# Administrative Approval Action

SR-102-18 / Bojangles' Restaurant  
Transaction# 574240 AA#3974

**REQUEST:** Development of a 1.62 acre tract zoned IX-3-PL into a proposed 4,180 sf restaurant on 1.54 acres with .08 acres of right-of-way dedication

**FINDINGS:** City Administration finds that this request, with the below conditions of approval being met, conforms to the Unified Development Ordinance. This approval is based on a preliminary plan dated 4/25/2019 by *Development Engineering, Inc.*

**8 WEST ELEVATION - SUNDAY DRIVE**  
1/8" = 1'-0"

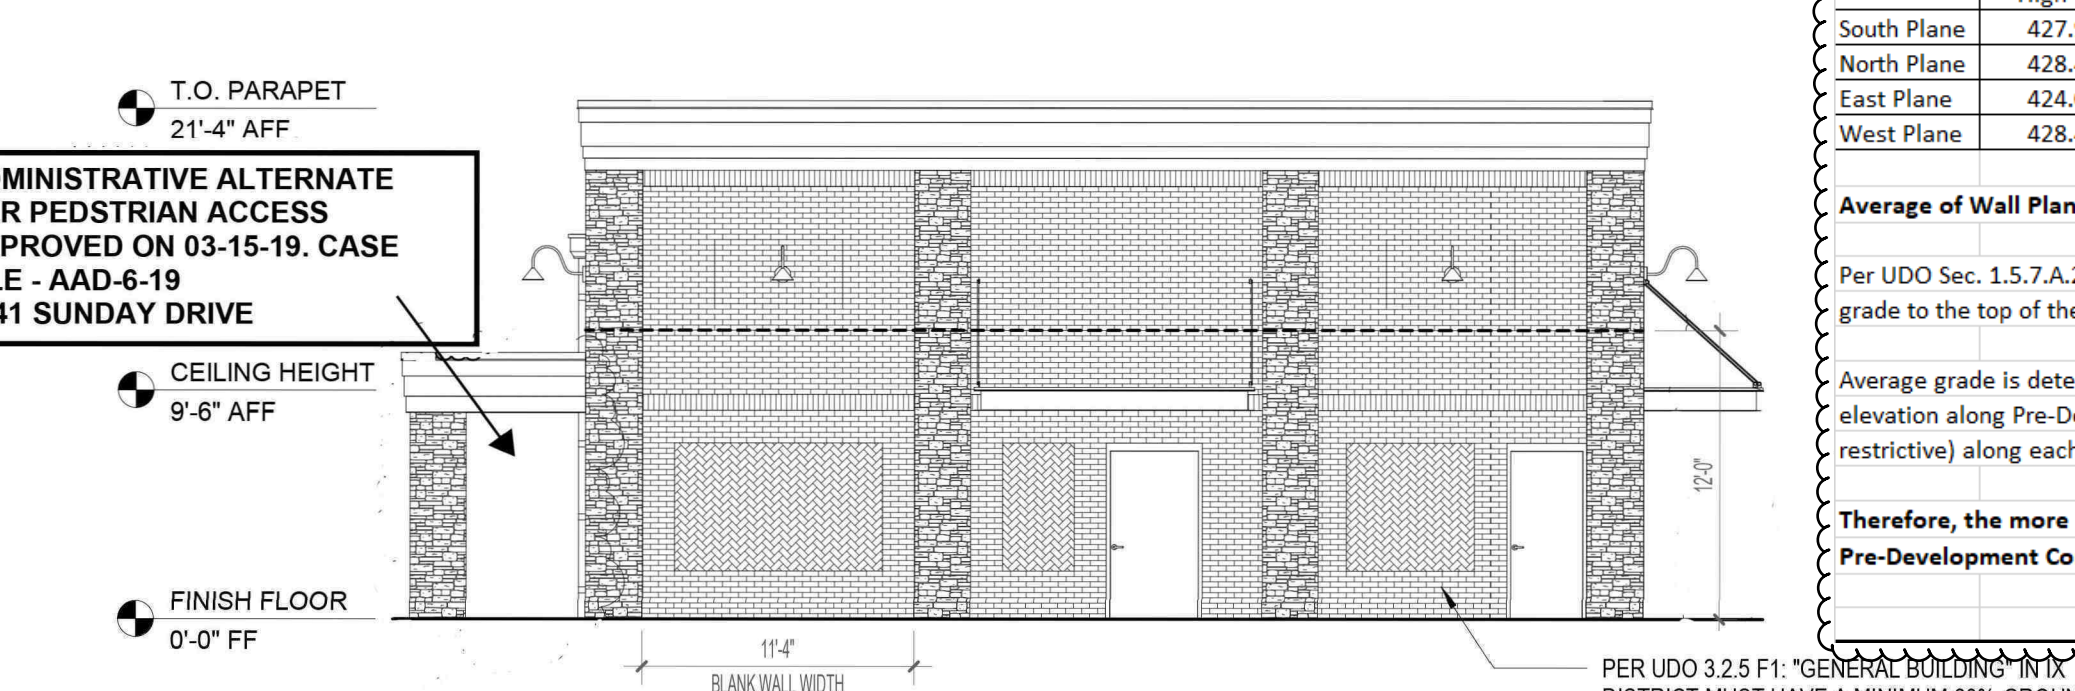
an alternate for the façade facing Sunday Drive, which currently offers no transparency as defined by the UDO.

To offset the reduction in transparency, the applicant is offering other strategies of adding visual interest to the façade. These include a canopy, lighting, and changes in material. There is also a landscaped area between the building and Sunday drive that contains hedges.

1. The approved alternate meets the intent of the transparency requirements;  
*Staff Response: The requested alternate meets the intent of the transparency requirements. The use of material changes, landscaping, and other architectural treatments provide visual interest for pedestrians and minimize blank wall area.*

- LU 2.1 – Placemaking
  - UD 1.2 – Architectural Features
  - UD 1.3 – Creating Attractive Facades
3. The street-facing building façade utilizes other architectural treatments to create visual interest to offset the reduction in transparency.  
*Staff Response: The facade facing Sunday Drive utilizes changes in materials that mimic windows, a canopy, and lighting to offset the reduction in transparency.*
